FORM-BASED ZONING REPORT

▶ **FILE #:** 4-A-26-OB **AGENDA ITEM #:** 22
 POSTPONEMENT(S): 4/9/2026, 5/14/2026 **AGENDA DATE:** 7/9/2026
 ▶ **APPLICANT:** RYAN ROBERTSON
 OWNER(S): Doyle E Arp Kerbela Temple Holding Corp.

▶ **PROPOSED USE:** Multifamily

Zoning Administrator Report for Level III: Alternative Compliance Review

Corner Activation Narrative

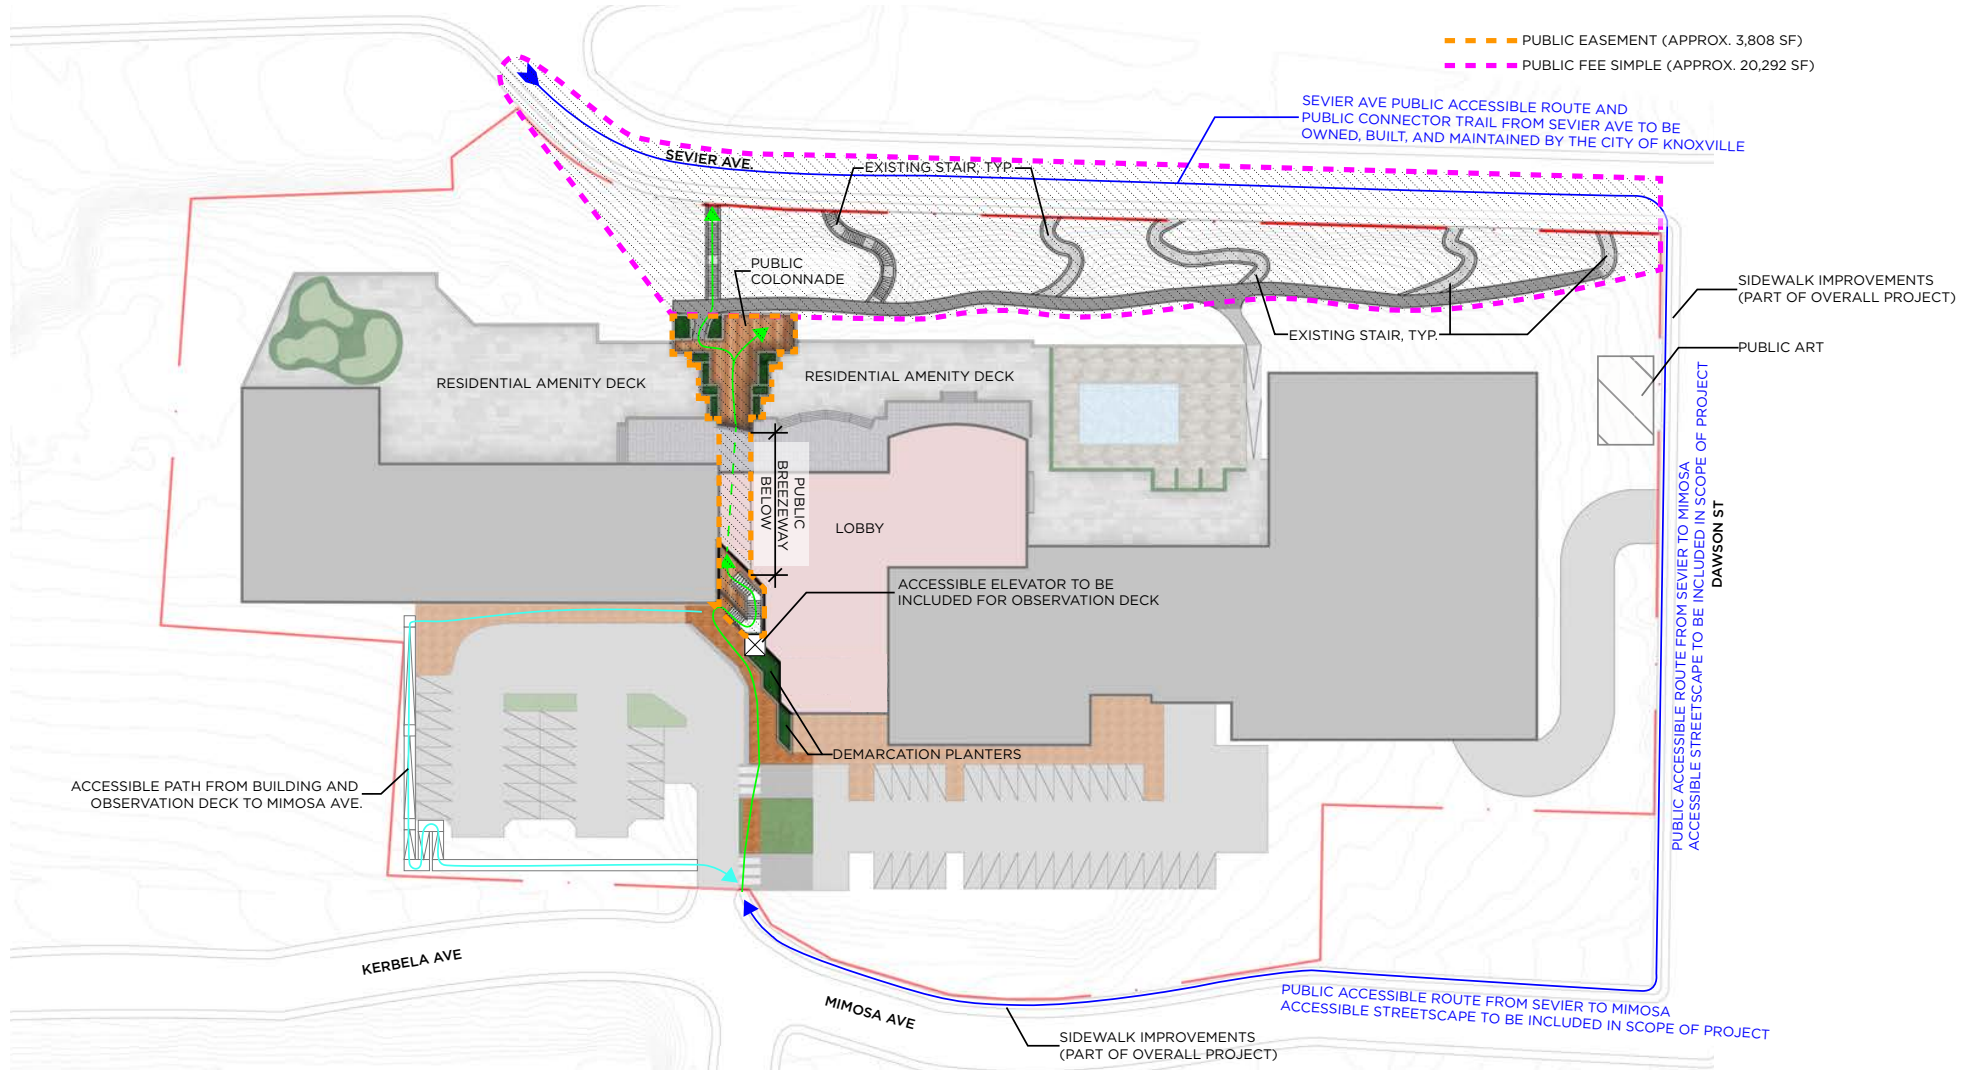
Several Commissioners expressed the need to activate the corner of Sevier Avenue and Dawson Street. One suggested solution was to build out the ground floor to allow conversion to commercial use later.

The Sevier/Dawson corner will serve as a primary activation point for development, transforming the existing condition through thoughtful architectural and hardscape enhancements. The design establishes a dynamic connection between the historic “ghost stairs” and the proposed east-west pedestrian corridor, strengthening pedestrian access to the project’s core public spaces while creating a more engaging streetscape experience.

A central feature of this connection is the existing rock pile, which will be preserved and elevated as a distinctive landmark element. Integrated landscape lighting will enhance its visual character and improve safety and visibility at the corner. Complementing this feature will be a signature public art installation — a large-scale bicycle sculpture, as an example — celebrating the area’s artistic identity while reinforcing the prominence of the adjacent bike lane and multimodal connectivity. Working with local sculptors to curate the most impactful installation for this area.

CURRENT SITE PLAN

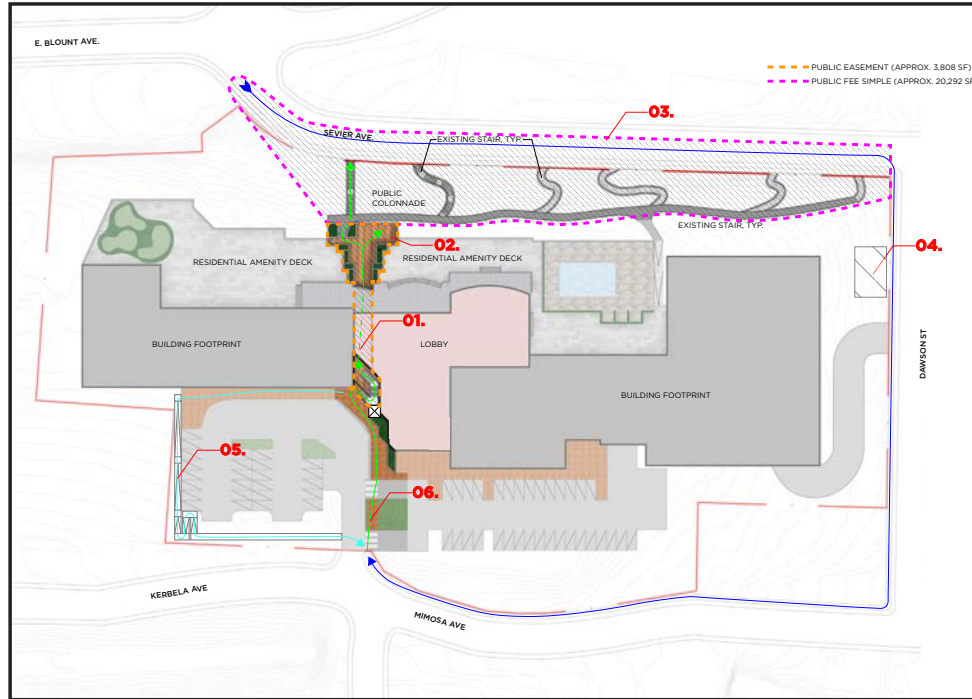
1. Extension of the east–west pedestrian pathway approximately 75 ft from the western “ghost stair” to a newly proposed public plaza comprising 1,400 sqft within a public use area of 2,400 sqft. The measurements are based on the information presented in the revised site plan. [Rendered Site Plan (New Design), page 34 of the plan set (revised 5/27/2026)]

2. Installation of approximately 155 ft of sidewalk and other streetscape improvements along Mimosa Avenue that would not otherwise be required per Article 7.1.5, Streetscape Standards, of the South Waterfront Form Code (SW code). [Rendered Site Plan (New Design), page 34 of the plan set (revised 5/27/2026)]

3. Lighting the existing rock pile and providing an art installation to activate the Sevier Avenue and Dawson Street corner of the property. [Rendered Site Plan (New Design), page 34 of the plan set (revised 5/27/2026), and the corner activation narrative in Exhibit D, applicant’s response document]

4. Lighting the ghost stairs. [Rendered Site Plan (New Design), page 34 of the plan set (revised 5/27/2026), and Exhibit D, applicant’s response document]

North Elevation - Glazing Diagram

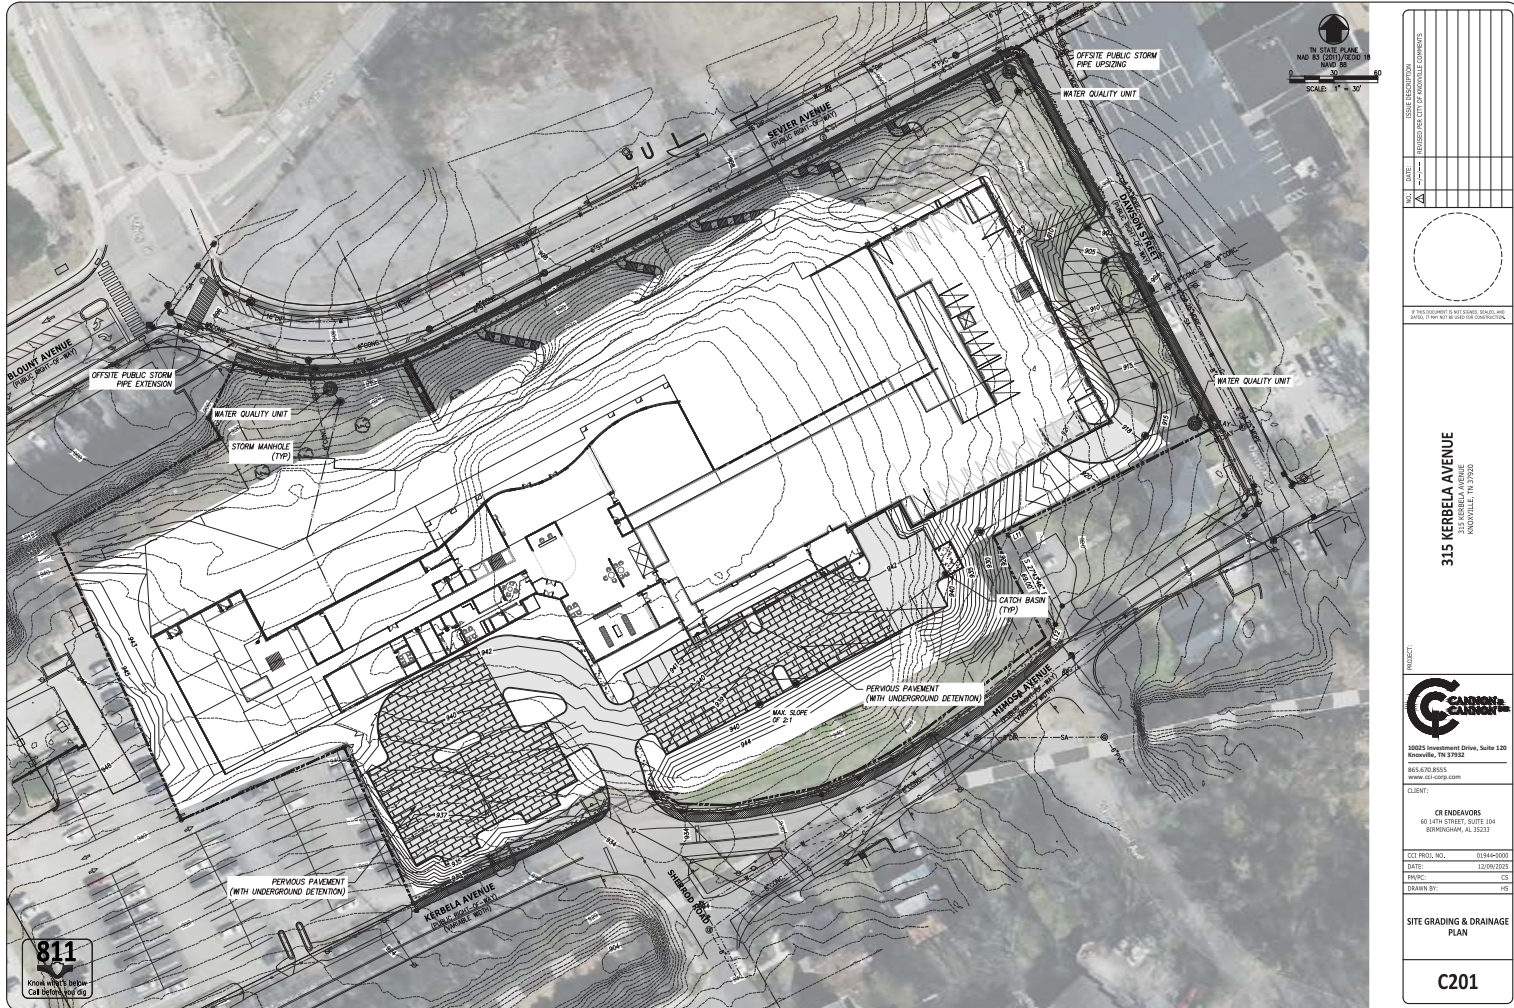
The provided elevations show a ground floor glazing calculation of 71%; however, there is a note that suggests that the ground floor area of the garage was excluded from the calculations. The ground floor area of the garage shall be included in the calculations, and the complete ground floor transparency calculation is unable to be determined on your elevation plan. Our updated ground floor glazing elevation reaches 63% due to the slope perpendicular to Dawson Street exceeding 22%.

Glazing Calc (not including garage):

- WALL AREA: 3,954 SF
- GLAZING AREA: 5,517 SF
- Glazing %: $3,954/5,517 = 71.7\%$

Glazing Calc (including garage):

- WALL AREA: 9,000 SF
- GLAZING AREA: 5,626 SF
- Glazing %: $5,626/9,000 = 62.5\%$

North Elevation

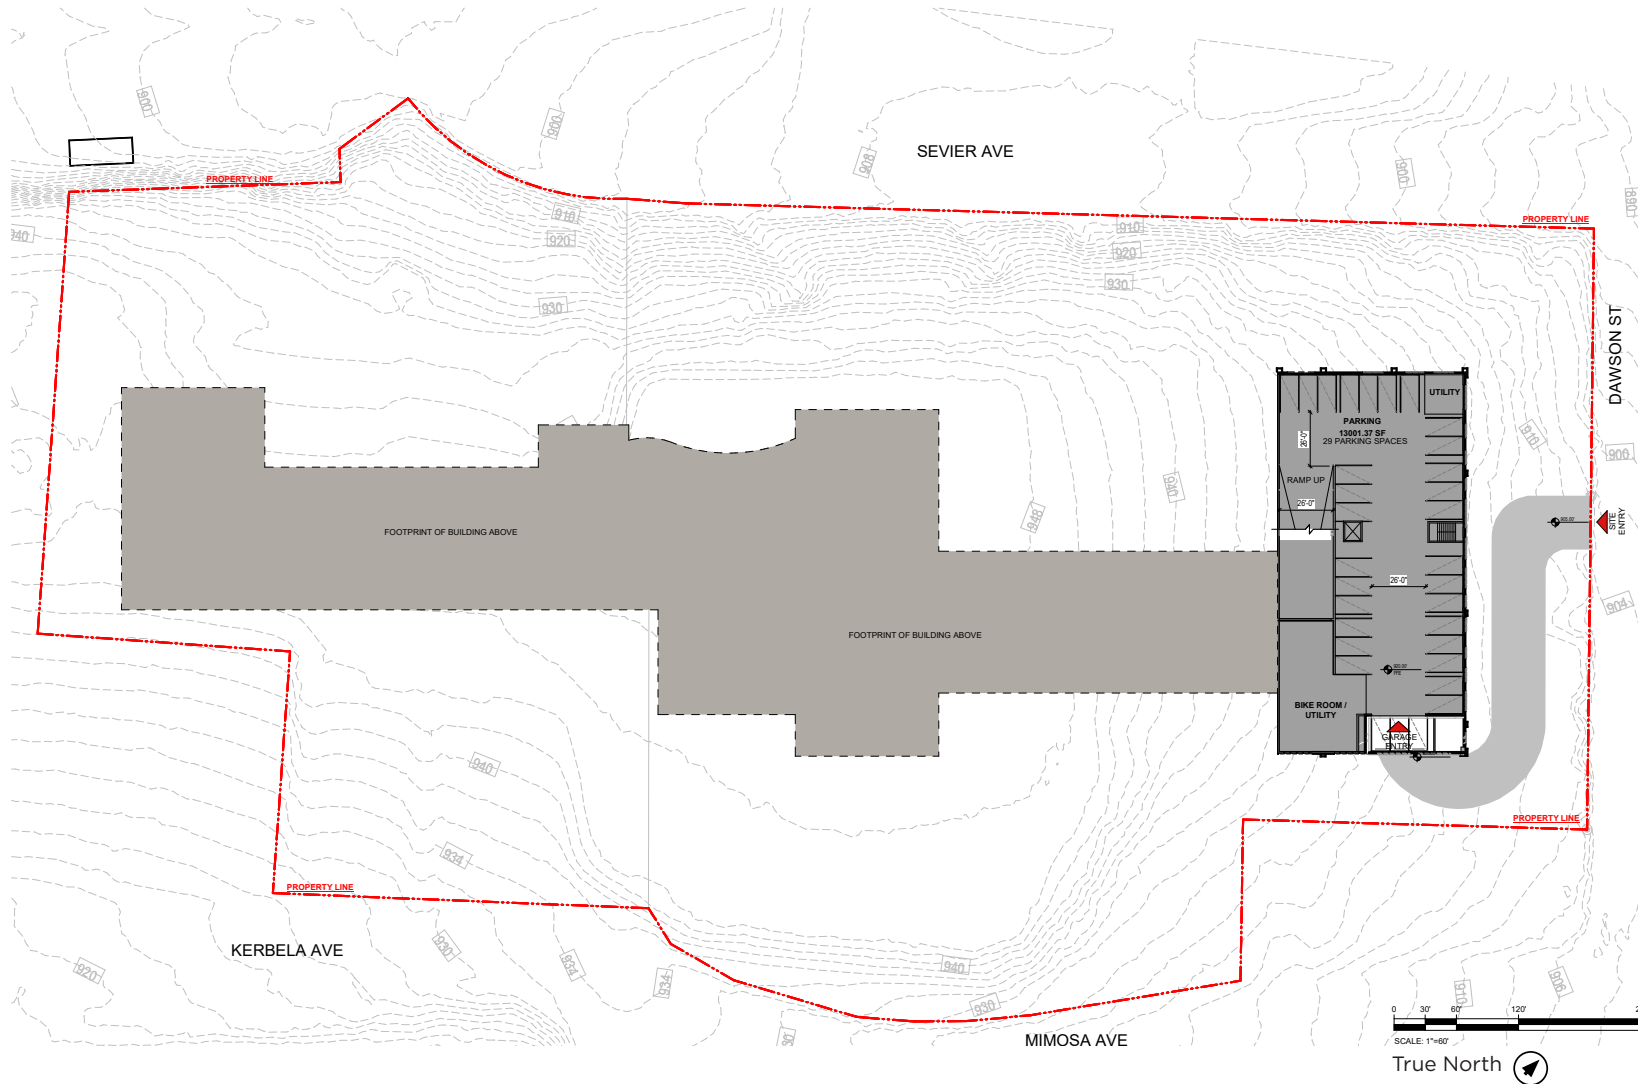
- Article 7.1.3.F.6 & 7.1.3.G.6– Building Entries – Ground Level - Min 70% transparent glass at the ground level on the principal frontage. The provided elevations show a ground floor glazing calculation of 63%. This will need approval as a Level III: Alternative Compliance Review.

Ground Floor Glazing Calculation:
 Wall Area: 5,714 SF*
 Glazing Area: 4100 SF*
 Percentage: 71.7%

*Glazing percentages do not include garage area
